STAFF UPDATE MEMO

SUBJECT: CUP 22-0005- Conditional Use Permit Request for additional height in the Downtown Commercial DC zoning district at 310 Midtown Way (Tax Map No. 257-(A)-217) by Foresight Design Services (applicant) for Midtown Redevelopment Partners, LLC (property owner)

Midtown Hotel CUP Request

SITE LAYOUT AND DIMENSION CONCEPT PLAN

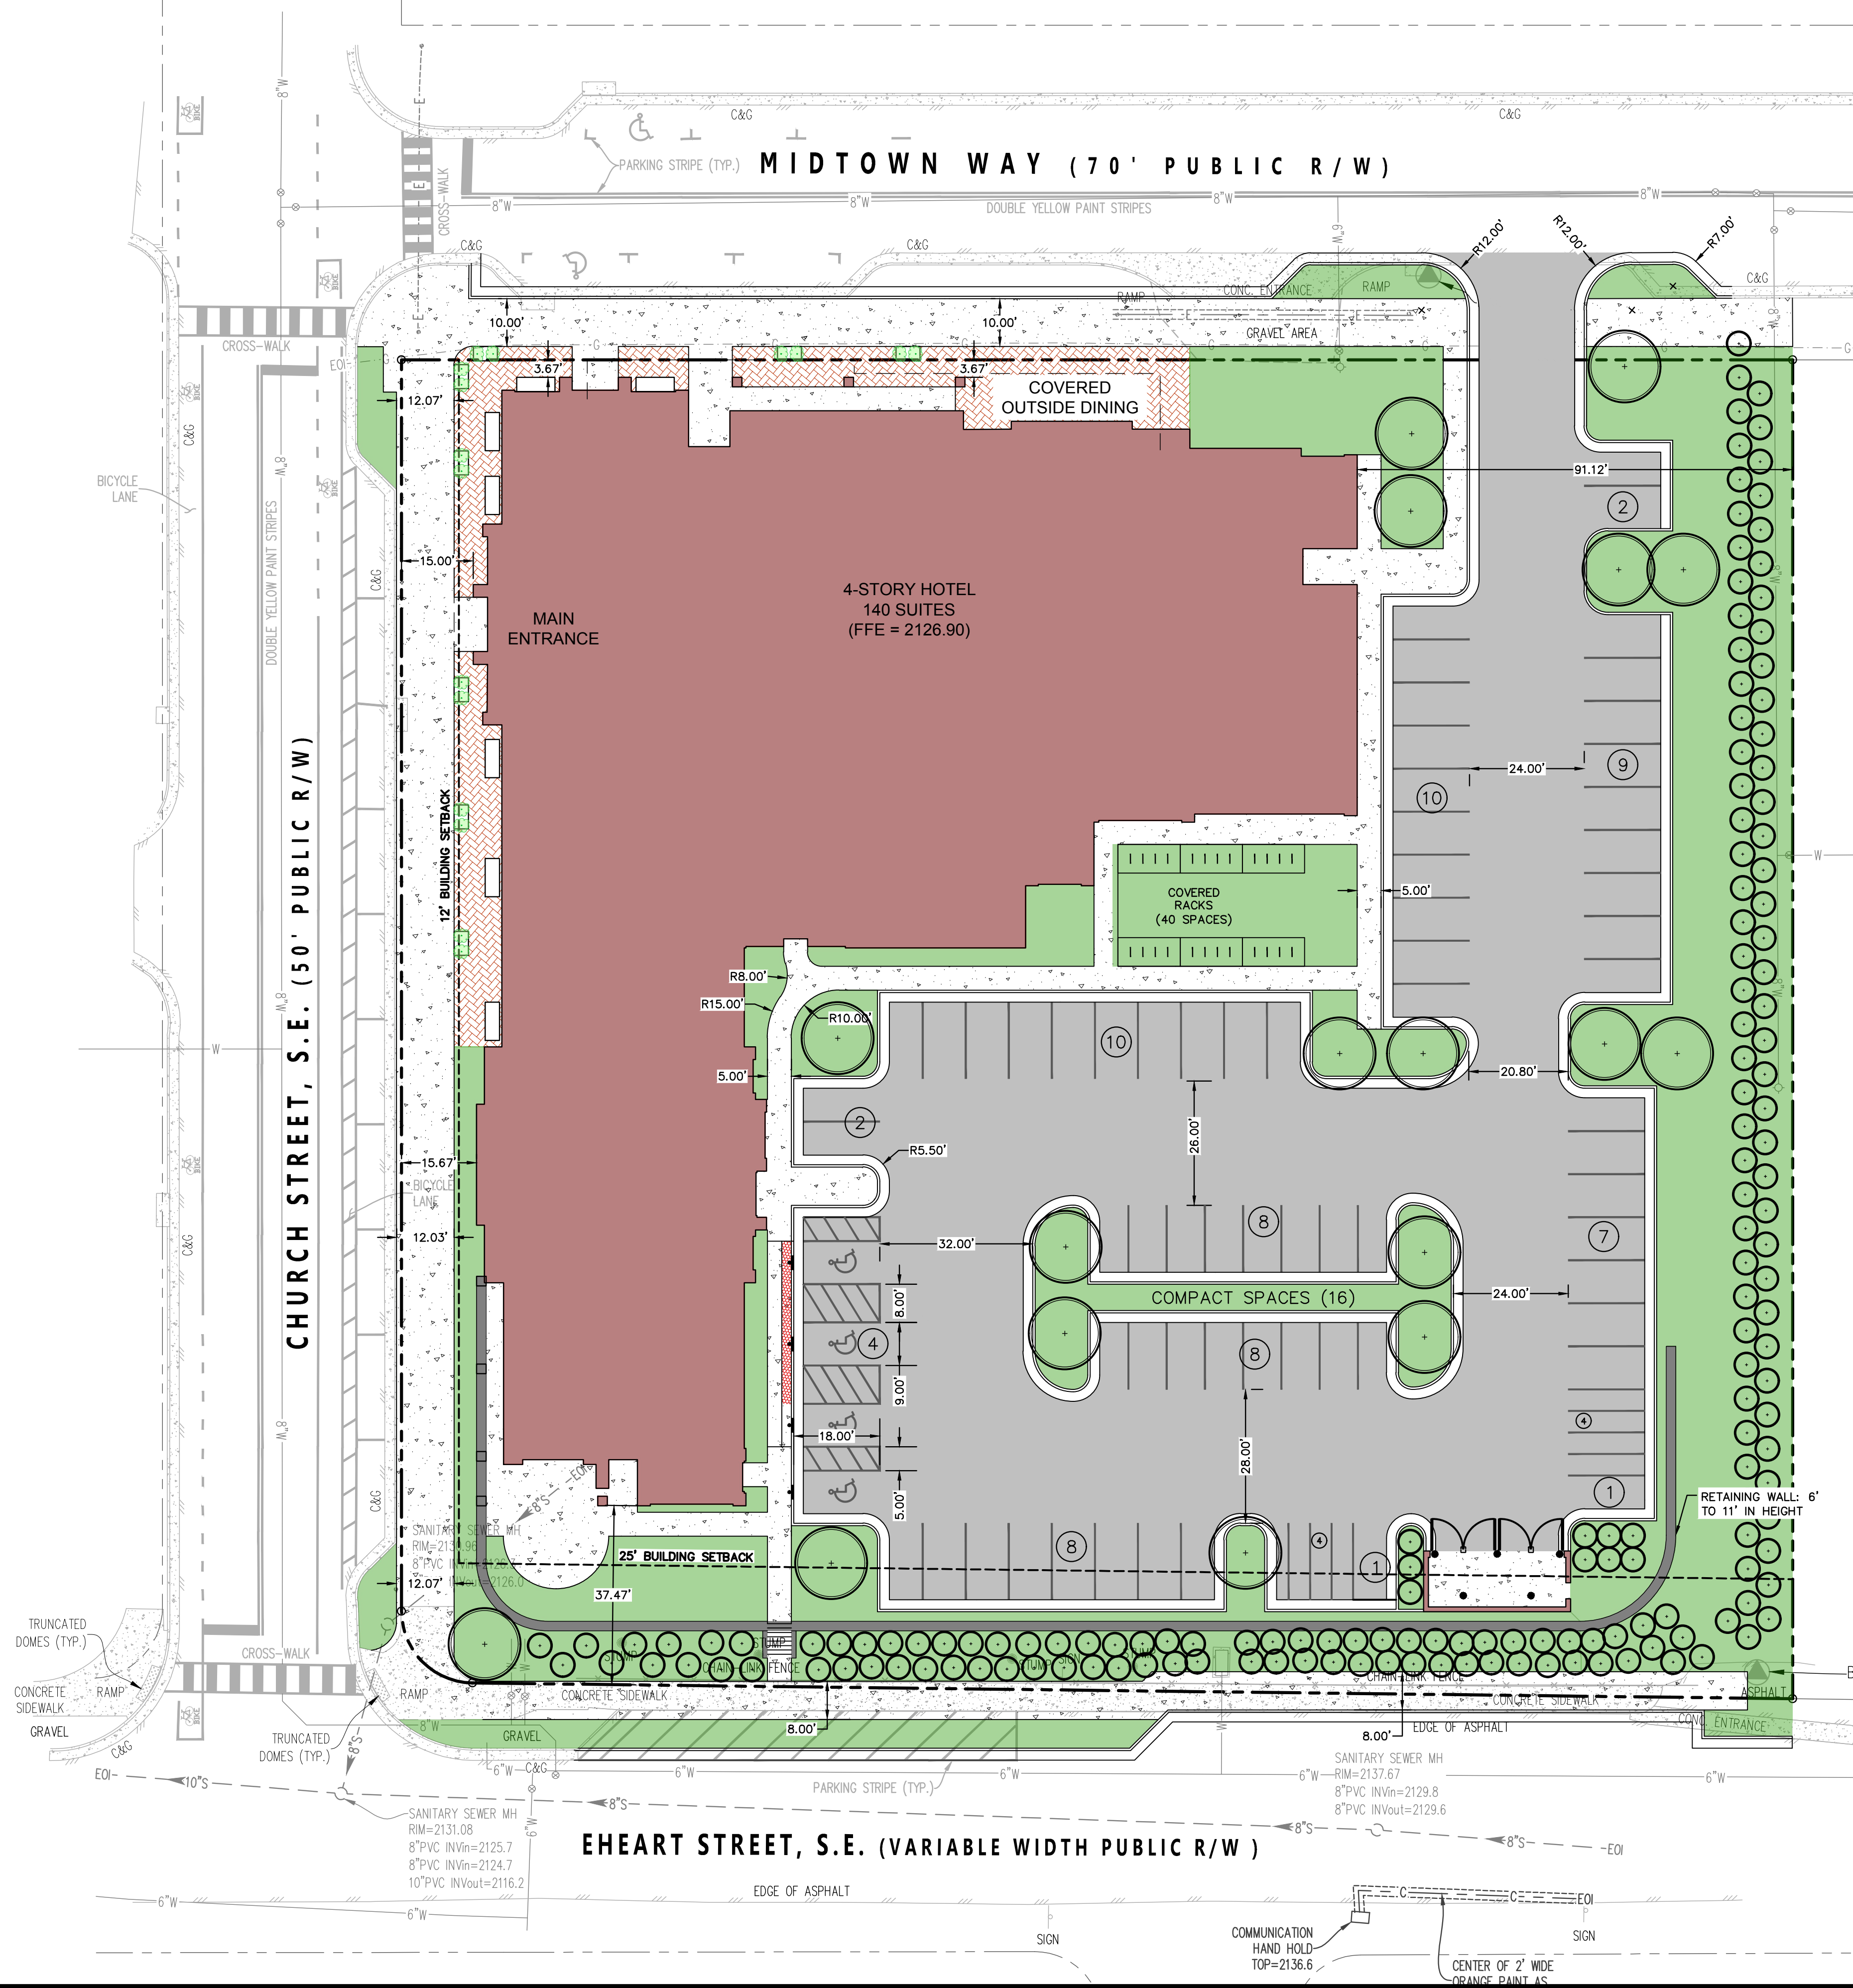
It was noted in the staff report that detailed dimensions were not provided to determine the building's setback from the property line, or curb, depending on how it is required to be measured per the Midtown rezoning. The revised concept plan shows the required dimensions:

- Midtown Way: 3.67' minimum from property line
 - *(0' minimum from property line required)*
- Church Street: 15' minimum from property line; or 15'+ from back of curb
 - *(12' minimum required from back of curb, which is just beyond the property line)*
- Eheart Street: 37.47' from property line
 - *(15' required minimum from property line)*
- Interior adjacent property: 91.12' from property line
 - *(20' required minimum from property line)*

It was noted in the staff report that the rezoning showed a continuous pedestrian connection through the property between Midtown Way and Eheart Street. This connection was not provided in total in the first submission. The revised concept plan shows a continuous sidewalk running along the building edge and parking lot to provide a connection through the site. While it is not a direct connection, it does satisfy the intent to provide the pedestrian through-connection.

- Widened sidewalk along portions of the building frontage closest to the street along Church Street and Midtown Way
 - The concept plan shows wider sidewalk extending from about mid-block on Church Street to just beyond the outdoor dining area along Midtown Way. This provides additional space along a portion of the building frontage, where the building is closest to the street. However, the wider sidewalk does not correspond to the entire frontage of the building, or the entire frontage of the parcel. The increased height of the building corresponds to the entire frontage of Church Street, and so the wider sidewalk should be provided along the Church Street frontage.
No details regarding materials were included, though the revised concept plan indicates a herringbone pattern. The wider sidewalk should feel like a seamless transition from the public sidewalk. Details regarding this transition and materials may be verified at the site plan stage.

The revised concept plan also shows sidewalk extending past the vehicle entrance to the adjacent property line with the townhomes to the east.
- Eight (8) planter areas at the back of the “public” sidewalk along Church Street and Midtown Way

- The concept plan shows planter boxes with landscaping between the “public” sidewalk and the widened sidewalk provided by the developer interspersed along the building frontage with wider sidewalk. Five (5) planter areas are provided along Church Street, and three (3) planter areas are provided along Midtown Way. Since the wider sidewalk does not extend the full building or parcel frontage, these planters are confined to the area where there is additional sidewalk width. However, as stated in the recommended condition, the planters shall be provided one per every 50' of frontage. The Church Street frontage is approximately 267', and thus five planters would be required. The Midtown Way frontage is approximately 291', and thus five planters would also be required. In order to meet the recommended condition, two more planters should be

provided along Midtown Way. Planning Commission may also determine that the proposed planters and their relationship to the building façade and streetscape are adequate, and revise the condition.

- Benches are provided along the building façade in the widened sidewalk area. A total of seven (7) benches are proposed.
 - The revised concept plan shows benches (white blocks) along the building frontage in the area where the wider sidewalk is provided. No other street furnishings are proposed. Details regarding materials and design were not provided. The street furnishings should match either those selected within the Midtown development, or the Town standard furnishings for the Downtown Commercial zoning district, depending on location. The staff-recommended condition has been revised to provide this clarification.

- One additional street tree is provided south of the building
 - The revised plan shows one additional street tree between the public sidewalk and the retaining wall near the southwest building corner.

- Some additional landscaping provided to screen parking from view of Midtown Way
 - The revised concept plan shows five additional trees near the vehicle entrance. These trees will be beneficial in helping to soften the additional height of the building, but do not provide ground-level screening. Additional shrubs may be appropriate if they do not block sight distance for vehicles exiting the site.

- Additional landscaping is provided to shield parking and building from view of the neighboring PR parcel
 - The revised concept plan shows a double-row of shrubs interior to the property line adjacent to the PR parcel.

- The Hotel and Parking lot have been slightly shifted to allow for a continuous sidewalk to connect from Midtown Way through the site to Eheart Street.
- An additional row of landscaping shrubs has been added to the East boundary with the PR area to buffer from the proposed parking.
- A list of shrubs have been provided on the concept plan for utilization throughout the site.
- Two new parking lot landscaping islands with trees have been added to the parking area adjacent to the PR area to provide some buffer between the proposed hotel building and the Townhomes.
- Additional hardscaping area has been added along the face of the hotel on both Midtown Way and Church Street as was envisioned in the original rezoning. Multiple planter boxes and benches have been illustrated however we would request the opportunity to mix and match these in equivalent numbers to the overall shown.
